Re: Former Chevron Service Station No. 9-3864  
5101 Telegraph Avenue, Oakland, California

Re: Former Chevron Service Station #9-3864  
5101 Telegraph Avenue  
Oakland, California  
SES Project #1-203-04

### RISK ASSESSMENT COMMENTS CHEVRON SERVICE STATION #9-3864 5101 TELEGRAPH AVE., OAKLAND, CA

Figure 1. Monitoring Well Location and Ground Water Elevation Contour Map - December 14, 1993 - Former Chevron Service Station #9-3864, 5101 Telegraph Avenue, Oakland, California

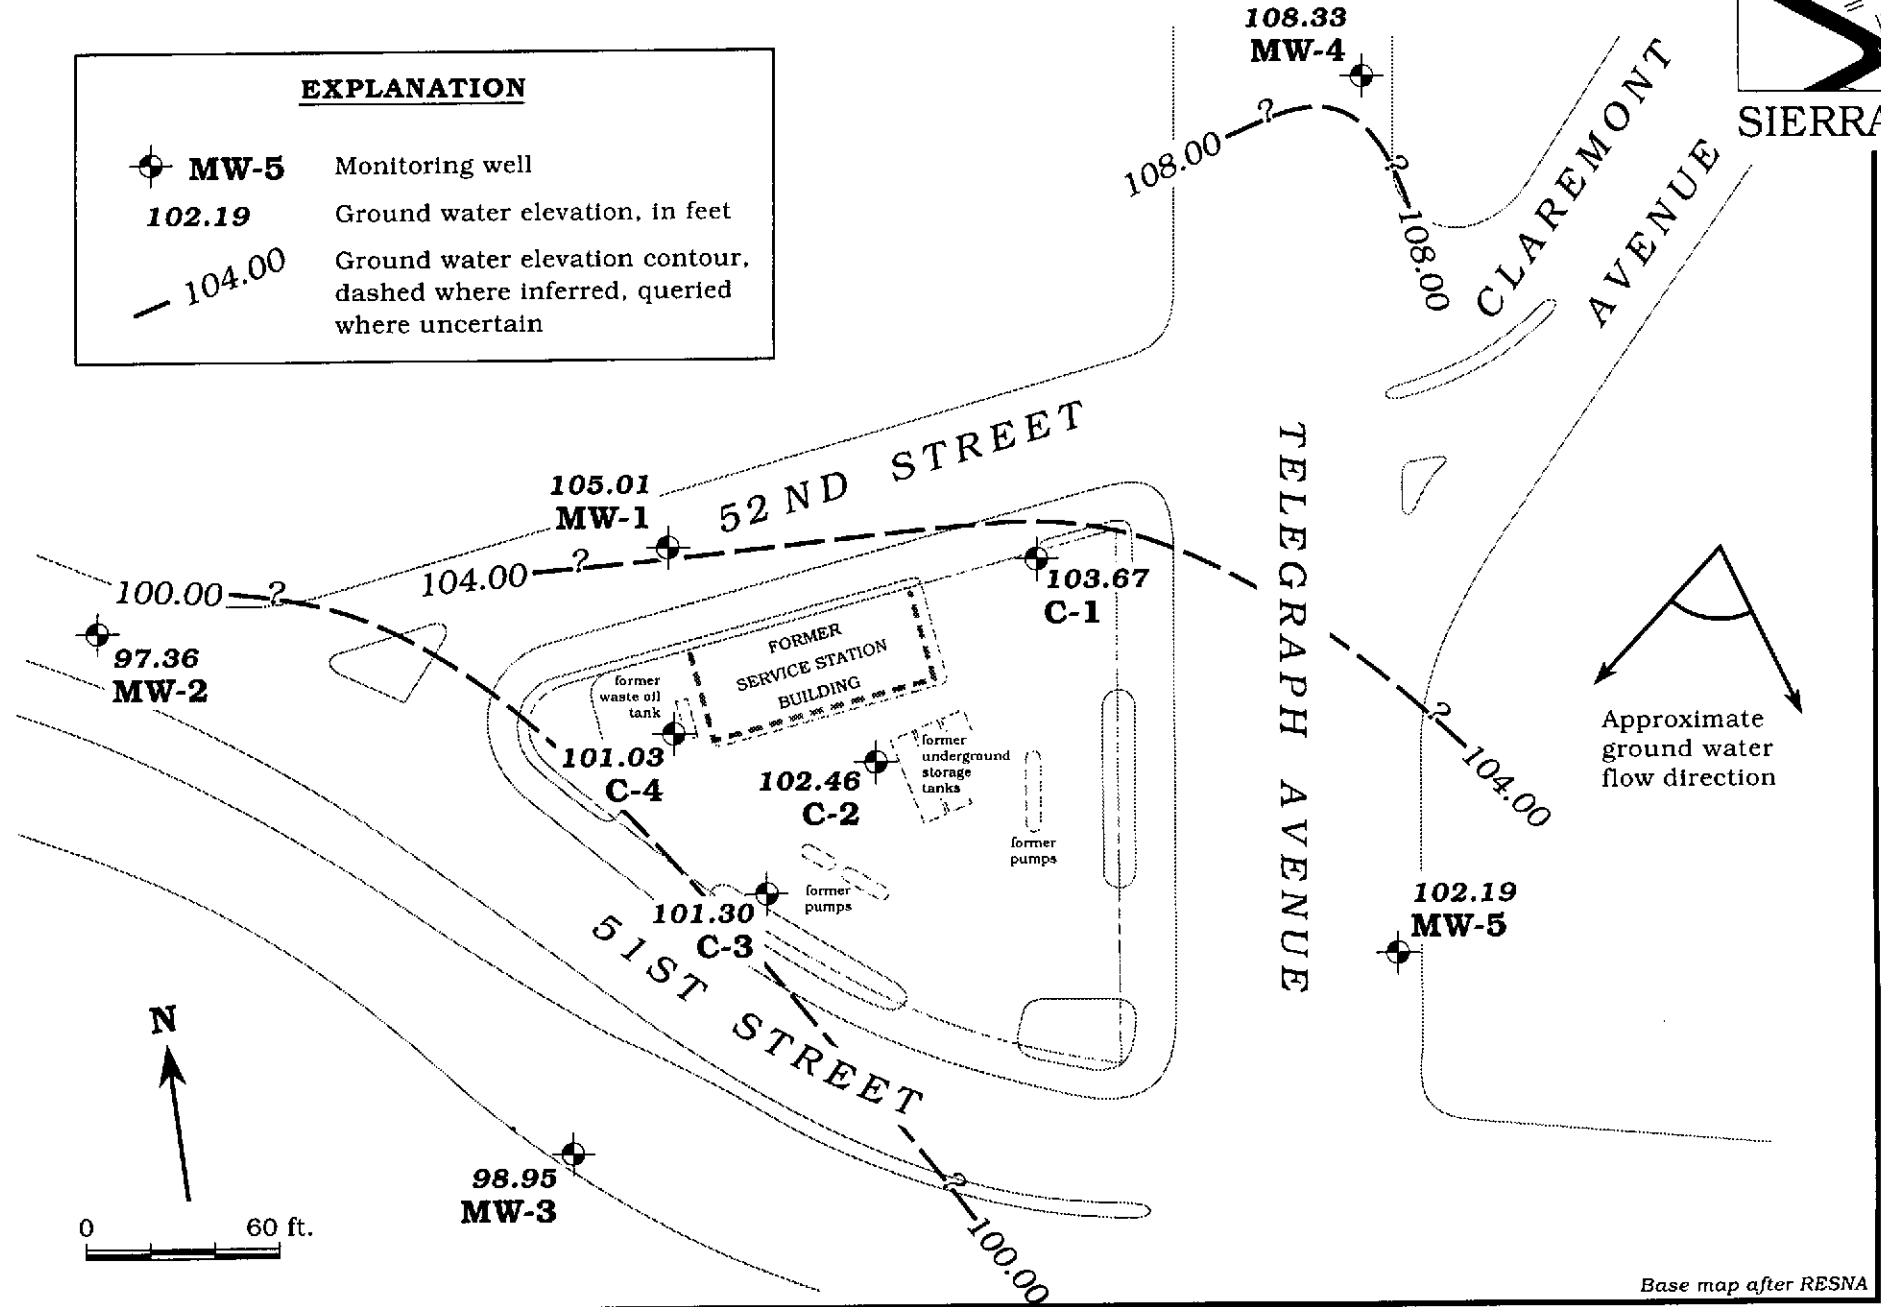
The latest groundwater results does not confirm that Chevron has not fully investigated the site. The latest results does confirm that off-site sources are contributing to the contamination of the groundwater because of the dissolved hydrocarbons found in wells MW-4 and MW-5. The fact that another off-site source does exist south of the site provides an explanation for the contamination in well MW-3. These potential off-site sources do exist, and they are possibly contributing or partially causing Chevron's groundwater contamination. During the meeting on November 18, 1993 at the Regional Board's office, the property owner's son, Mr. John L. Gwynn, did confirm while looking at an aerial photograph that a service station did exist in the vicinity of MW-3. Regarding the change in groundwater, it is not an uncommon phenomenon.

of MW-1 and MW-2. Monitoring data shows groundwater flowing in the south -easterly and -  
westerly direction.
